APPLICATION NO.	FILING DATE	FIRST NAMED INVENTOR	ATTORNEY DOCKET NO.	CONFIRMATION NO.
10/646,923	08/25/2003	Hong-gie Hwang	1293.1884	1952
21171	7590	08/09/2007	EXAMINER	
STAAS & HALSEY LLP SUITE 700 1201 NEW YORK AVENUE, N.W. WASHINGTON, DC 20005				FLORES RUIZ, DELMA R
ART UNIT		PAPER NUMBER		
		2828		
MAIL DATE		DELIVERY MODE		
		08/09/2007		
		PAPER

Office Action Summary	Application No.	Applicant(s)	
	10/646,923	HWANG, HONG-GIE	
	Examiner	Art Unit	
	Delma R. Flores Ruiz	2828

DETAILED ACTION

Fig. 5**Fig. 6**

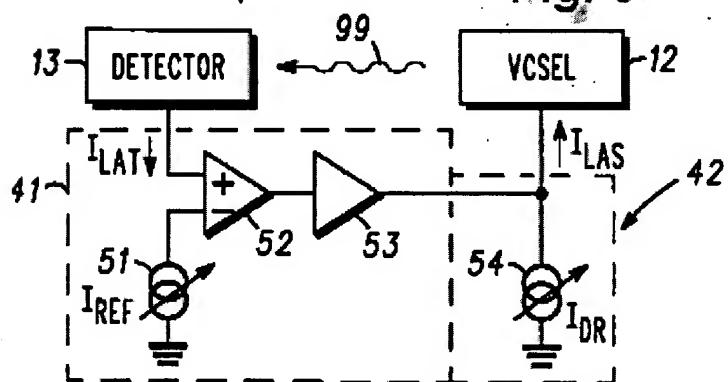
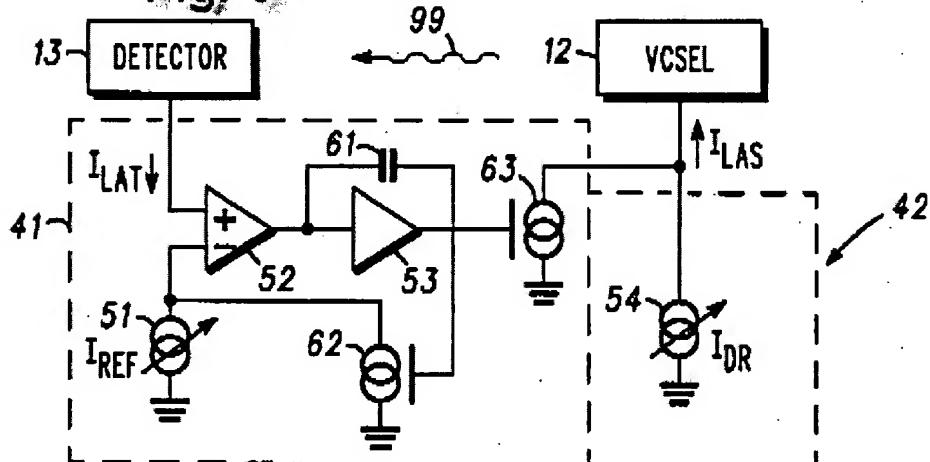
Regarding claim 1, Kiely shown Figures 5 and 6, discloses a method of automatically controlling an output power of a laser diode (see Figs. 5 and 6, Character 12, the reference call “VCSEL”), the method comprising: generating an error voltage between an output voltage of the laser diode sampled during an automatic power control period (see Figs. 5 and 6, Character 13) and a reference voltage (see Figs. 5 and 6, Character 52); proportional integral control (see Fig. 6 Characters 53 and 61, Column 6, Lines 39 –42) and the error voltage to generate a compensated control voltage (it has been held that a recitation with respect to the manner in which a claimed apparatus is intended to be employed does not differentiate the claimed apparatus from

a prior art apparatus satisfying the claimed structural limitations. Ex Parte Masham, 2 USPQ F.2d 1647 (1987)) and applying the compensated control voltage to the laser diode (see Fig. 5 and 6, Character 12, the reference call "VCSEL").

Regarding claim 3, Kiely shown Figures 5 and 6, discloses a compensated control voltage applied to the laser diode is an effective control voltage within a predetermined range (see Figs. 5 and 6, Character 13).

Regarding claim 7, Kiely shown Figures 5 and 6, discloses a computer readable medium having embodied thereon a computer program for automatically controlling an output power of a laser diode comprising: generating an error voltage between an output voltage of the laser diode (see Figs. 5 and 6, Character 12, the reference call "VCSEL") sampled during an automatic power control period (see Figs. 5 and 6, Character 13) and a reference voltage (see Figs. 5 and 6, Character 52); proportional integral control (see Fig. 6 Characters 53 and 61, Column 6, Lines 39 –42) and the error voltage to generate a compensated control voltage (it has been held that a recitation with respect to the manner in which a claimed apparatus is intended to be employed does not differentiate the claimed apparatus from a prior art apparatus satisfying the claimed structural limitations. Ex Parte Masham, 2 USPQ F.2d 1647 (1987)) and applying the compensated control voltage to the laser diode (see Fig. 5 and 6, Character 12, the reference call "VCSEL").

Regarding claim 9, Kiely shown Figures 5 and 6, discloses an apparatus to automatically control an output power of a laser diode, the apparatus comprising: an error voltage generation unit generating an error voltage between an output voltage of the laser diode (see Figs. 5 and 6, Character 12, the reference call "VCSEL") sampled during an automatic power control period (see Figs. 5 and 6, Character 13) and a reference voltage (see Figs. 5 and 6, Character 52); and a control voltage generation unit performing proportional integral control (see Fig. 6 Characters 53 and 61, Column

6, Lines 39 –42) and the error voltage to generate a compensated control voltage (it has been held that a recitation with respect to the manner in which a claimed apparatus is intended to be employed does not differentiate the claimed apparatus from a prior art apparatus satisfying the claimed structural limitations. Ex Parte Masham, 2 USPQ F.2d 1647 (1987)) and applying the compensated control voltage to the laser diode (see Fig. 5 and 6, Character 12, the reference call “VCSEL”).

Regarding claims 4, 8 and 10 Kiely shown Figures 5 and 6, discloses a method of automatically controlling an output power of a laser diode (see Figs. 5 and 6, Character 12, The reference call “VCSEL”), the method comprising: generating an error voltage between an output voltage of the laser diode sampled during an automatic

power control period (see Figs. 5 and 6, Character 13) and a reference voltage (see Figs. 1, Character 52); proportional integral control (see Fig. 6 Characters 53 and 61, Column 6, Lines 39 –42) and the error voltage to generate a compensated control voltage (it has been held that a recitation with respect to the manner in which a claimed apparatus is intended to be employed does not differentiate the claimed apparatus from a prior art apparatus satisfying the claimed structural limitations. Ex Parte Masham, 2 USPQ F.2d 1647 (1987)) and applying the compensated control voltage to the laser diode (see Fig. 5 and 6, Character 12, the reference call "VCSEL").
